EASA	AIRWORTHINESS DIRECTIVE
	<p>AD No.: 2013-0280</p> <p>Date: 26 November 2013</p> <p>Note: This Airworthiness Directive (AD) is issued by EASA, acting in accordance with Regulation (EC) No 216/2008 on behalf of the European Community, its Member States and of the European third countries that participate in the activities of EASA under Article 66 of that Regulation.</p>
<p>This AD is issued in accordance with EU 748/2012, Part 21.A.3B. In accordance with EC 2042/2003 Annex I, Part M.A.301, the continuing airworthiness of an aircraft shall be ensured by accomplishing any applicable ADs. Consequently, no person may operate an aircraft to which an AD applies, except in accordance with the requirements of that AD, unless otherwise specified by the Agency [EC 2042/2003 Annex I, Part M.A.303] or agreed with the Authority of the State of Registry [EC 216/2008, Article 14(4) exemption].</p>	
<p>Design Approval Holder's Name: ATR-GIE AVIONS de TRANSPORT RÉGIONAL</p>	<p>Type/Model designation(s): ATR 72 and 42 aeroplanes</p>

TCDS Number:	EASA A.084
Foreign AD:	Not applicable
Supersedure:	None
ATA 25	Equipment / Furnishing – Type III Emergency Exit Door – Inspection / Modification
Manufac

Figure 1: IPC 25-23-02 fig 87

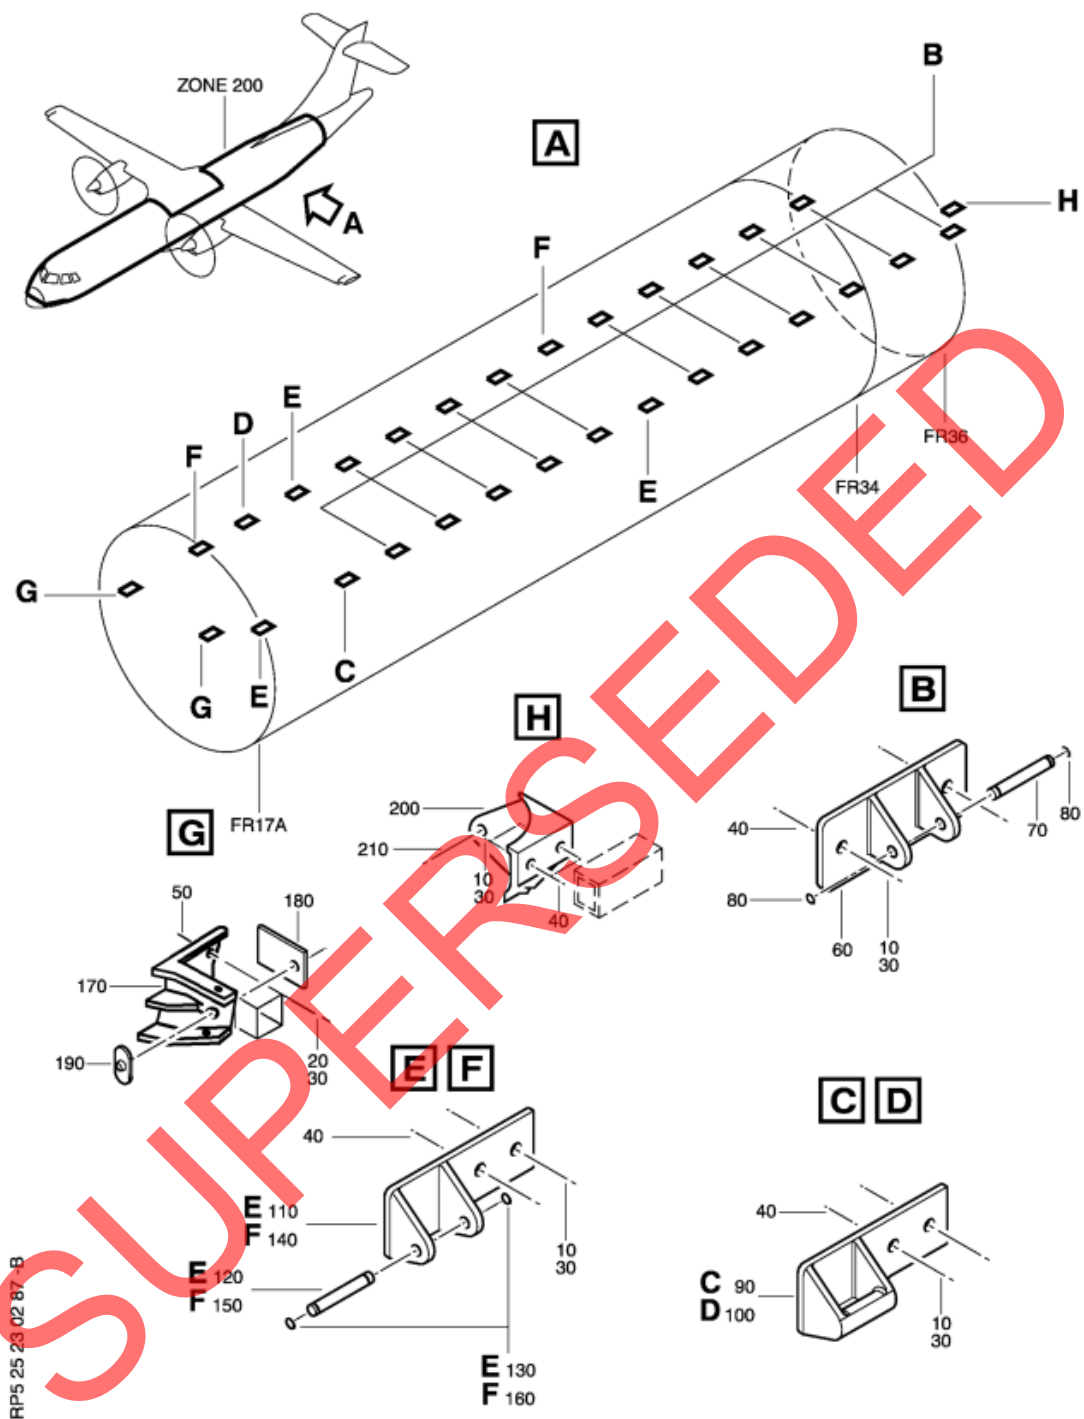
Reason:	<p>Interference between a Type III Emergency Exit door opening and the surrounding passenger cabin furnishing was detected during a production check.</p> <p>Subsequent investigation identified an insufficient gap between the Emergency Exit door internal skin structure and the overhead stowage compartment fitting, installed on the rail, as a cause of the interference.</p> <p>This condition, if not detected and corrected, could prevent an unobstructed opening of both Type III Emergency Exit doors in case of emergency evacuation.</p> <p>For the reasons described above, this AD requires a one-time check of the gap</p>

between the Type III Emergency Exit door internal skin and a relevant fitting and, depending on findings, the accomplishment of applicable corrective action(s). This AD is considered to be a temporary measure and further actions may follow.
Effective Date:	10 December 2013
Required Action(s) and Compliance Time(s):	<p>Required as indicated, unless accomplished previously:</p> <p>(1) Within 2 months after the effective date of this AD, measure the gap between each Type III Emergency Exit door, left hand (LH) and right hand (RH), and the overhead stowage compartment fitting installed on the rail, by unlocking and slightly rotating the LH and RH Type III Emergency Exit door, remaining on their lower fittings. Use a shim gauge 6 mm (0.236 in) thick, to measure the gap between the doors internal skin and the relevant fittings, P/N S2522924620000 (LH) and P/N S2522924620100 (RH).</p> <p>Note 1: For illustrations refer to the applicable ATR Illustrated Parts Catalogue (IPC) 25-23-02 fig 87 item 90/100 and to Appendix 1 of this AD.</p> <p>Note 2: It might be necessary to locally pull on the door blanket to correctly see the door internal skin.</p> <p>(2) If, during the measurement as required by paragraph (1) of this AD, a gap equal to or more than 6 mm (0.236 in) is detected, before next flight, re-install the LH and RH Type III Emergency Exit door, in accordance with the instructions of the applicable ATR Aircraft Maintenance Manual (AMM) / Job Instruction Card (JIC) 52-21-00 RAI 10000.</p> <p>(3) If, during the measurement as required by paragraph (1) of this AD, a gap less than 6 mm (0.236 in) is detected, before next flight remove the fitting, P/N S2522924620000 LH or P/N S2522924620100 RH, as applicable, and measure the gap between the Type III Emergency Exit door internal skin, LH and RH, and the overhead stowage compartment hooks in accordance with the accomplishment instructions of ATR SB ATR42-25-0180 or ATR72-25-1141, as applicable to aeroplane model, and, depending on findings, accomplish the follow-on actions as specified in paragraph (3.1) or (3.2) of this AD, as applicable.</p> <p>(3.1) If, during the measurement as required by paragraph (3) of this AD a gap equal to or more than 6 mm (0.236 in) is detected, before next flight, re-install the LH and RH Type III Emergency Exit door in accordance with the instructions of ATR SB ATR42-25-0180 or ATR SB ATR72-25-1141, as applicable to aeroplane model.</p> <p>(3.2) If, during the measurement as required by paragraph (3) of this AD a gap less than 6 mm (0.236 in) is detected, before next flight, contact ATR to obtain approved repair instructions and accomplish the repair accordingly.</p>
